Addendum - 1

Stormwater Management Report

Large Scale Ground Mounted Solar Photovoltaic Installation

Revised: March 2019

PROPOSED HYDROLOGY

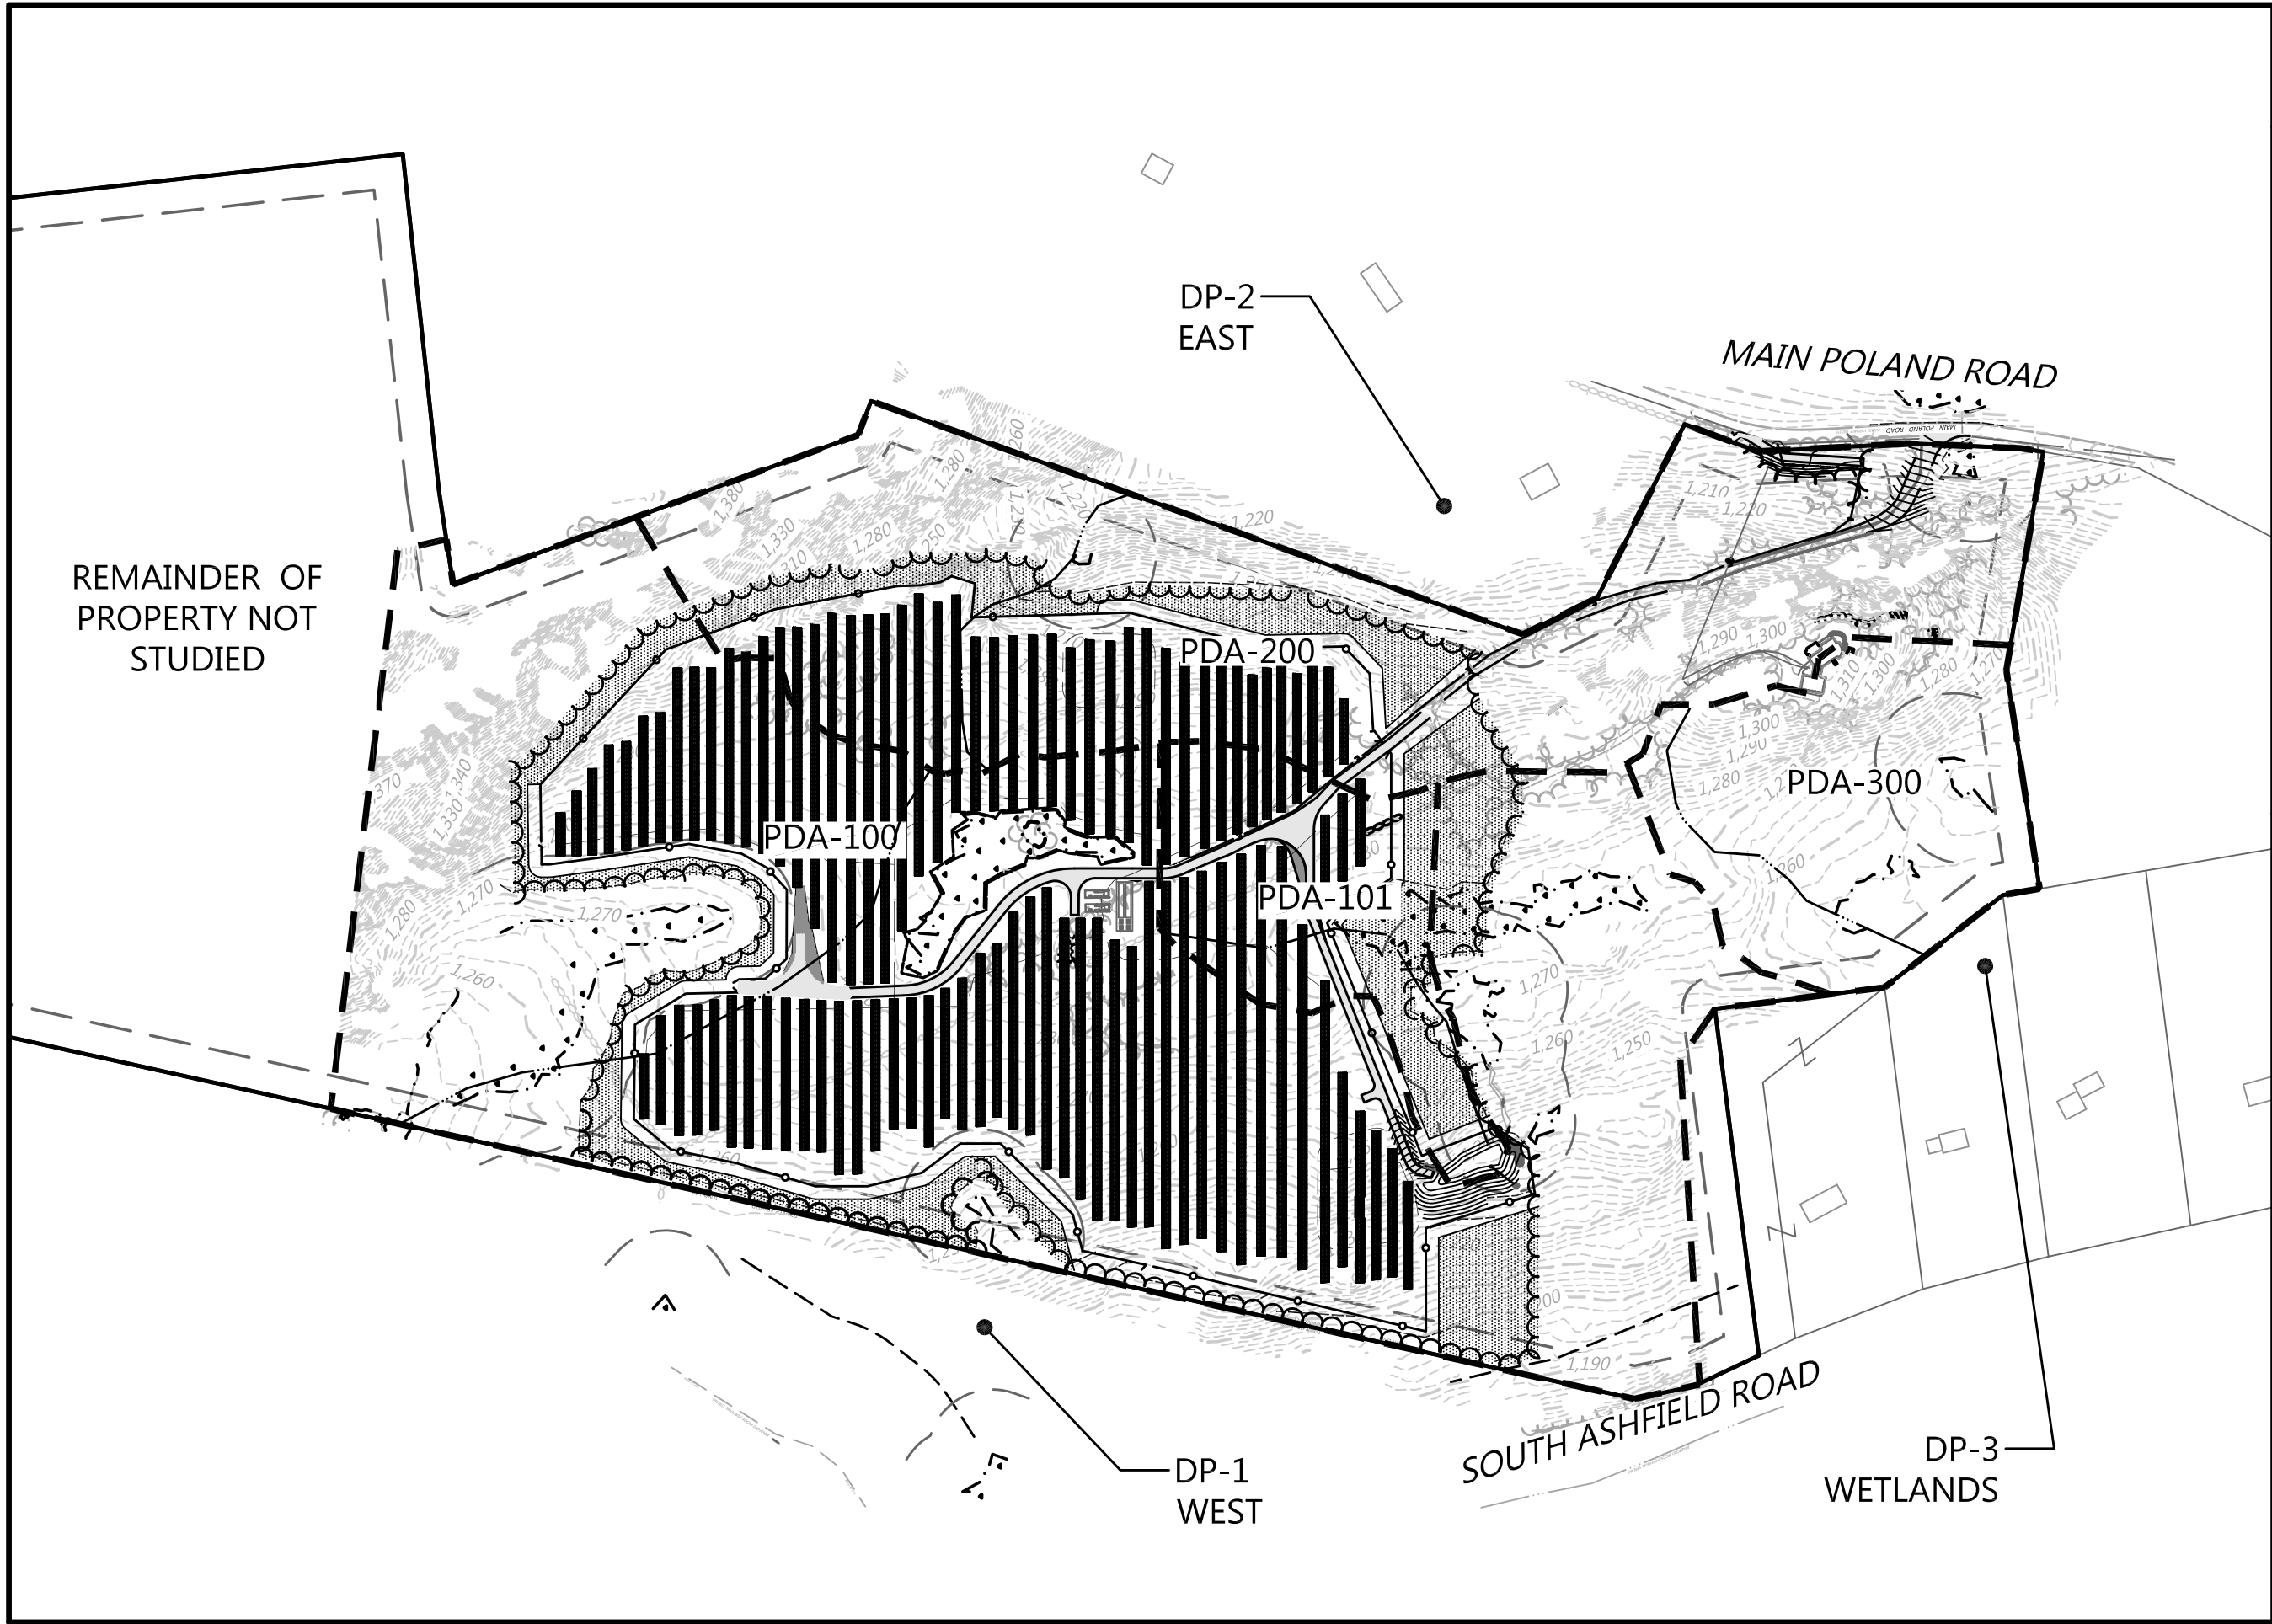
- a) the overall scope/scale of the project has been reduced, resulting in a smaller disturbed area in order to maintain a greater natural buffer to wetlands and provide a larger setback and buffer to neighboring lots.

- b) the post development times of concentration (T_c) have been reevaluated to reflect proper cover types of the proposed conditions. Areas of meadow inside the fence are evaluated as "dense grass", areas of brush to be cleared with stumps remaining are evaluated as "forest with heavy litter".

- c) trap rock check dams have been added to the existing drainage channel in the eastern drainage area (PDA-200) to increase times of concentration as well as mitigate existing runoff concerns.

- d) for proposed drainage area (PDA-200) the original time of concentration path was analyzed with revised cover types, which resulted in a large increase in the T_c . An alternate T_c path for PDA-200 is used in this Addendum as it provides an analysis more closely resembling the other areas of proposed disturbance, is closer to the T_c for existing site conditions and is therefore more conservative value than that of the original T_c path.

- e) The detention basin has been slightly enlarged to mitigate the peak flows and provide one-foot of free board.
